ELSMOR – towards European Licensing of Small Modular Reactors: Methodology recommendations for light-water small modular reactors safety assessment

REVISED **ELSMOR – towards European Licensing of Small Modular Reactors: Methodology recommendations for light-water small modular reactors safety assessment**

[version 2; peer review: 2 approved, 3 approved with reservations]

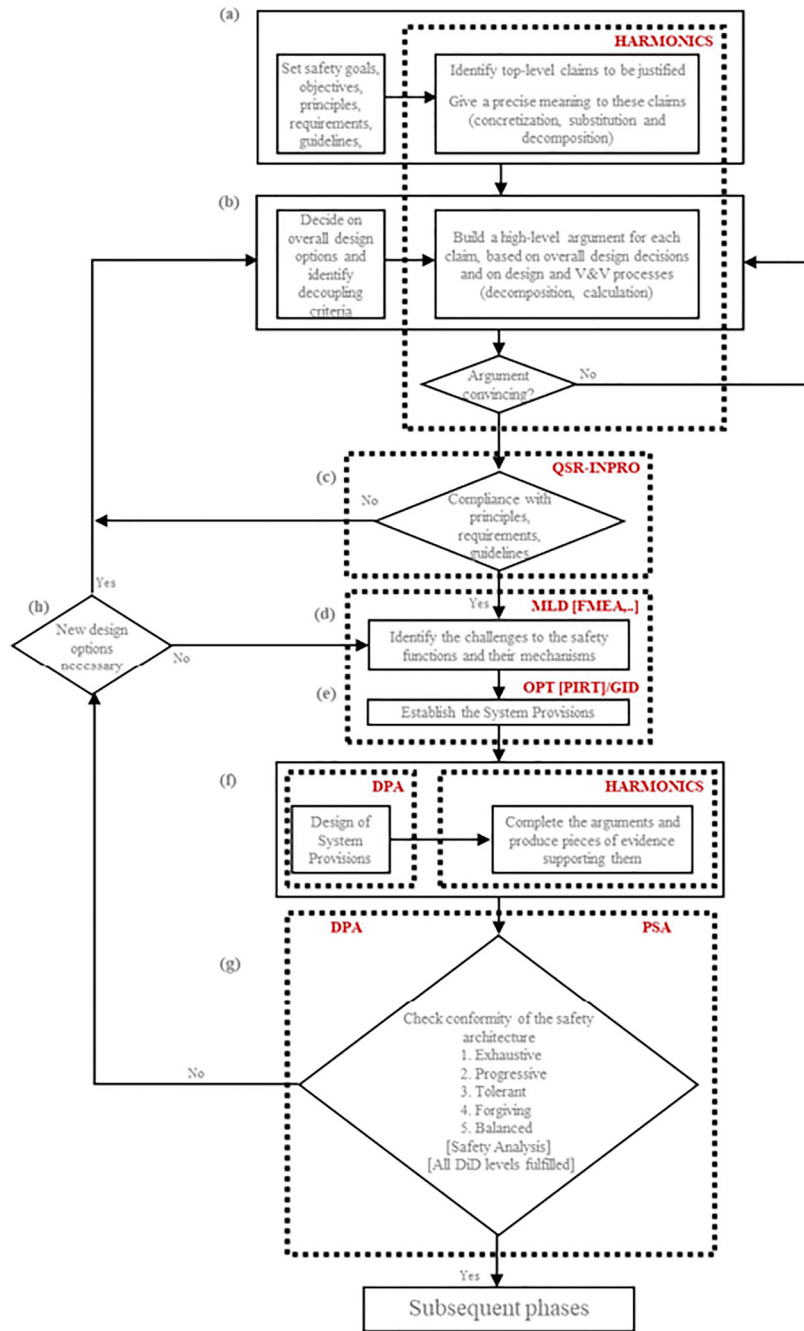
4. The methodological recommendations provided for LW-SMR safety assessment is based on the methodology shown in figure 1 (ELSMOR safety assessment methodology). Are these recommendations applicable to any other methodology for SMR safety assessment? Provide the basis for "Yes or No" answer.

7. Analytic and probabilistic safety analyses may be mentioned in Figure.1 since a quantitative method is needed for licensing an SMR.

4. Figure 1 is simplified comparing to Figure 1 of ELSMOR deliverable D2.2, which identifies also the steps of the ELSMOR methodology and the review methodologies (e.g. HARMONICS, QSR, PIRT, GID). The Open Letter has section 'Recommendations related to high-level safety methodologies used for a licensing', but later very few review methods are mentioned (e.g. ISAM is exception). Consider to provide some information or at least references for the review methodologies.

Figure 1 was updated to include further details on methods considered to develop the algorithm.

7. The Figure was changed for a more complete one, which includes, in particular, references to PSA methods.

4. A description of the methodologies reviewed (ISAM, INPRO, SARGEN_IV, HARMONICS) and used for the development of the ELSMOR safety assessment methodology has been added in the text of the article. References of the reviewed methodologies and the description of their content are described in ELSMOR Deliverable 2.2 to which a cross-link has been added in the text.
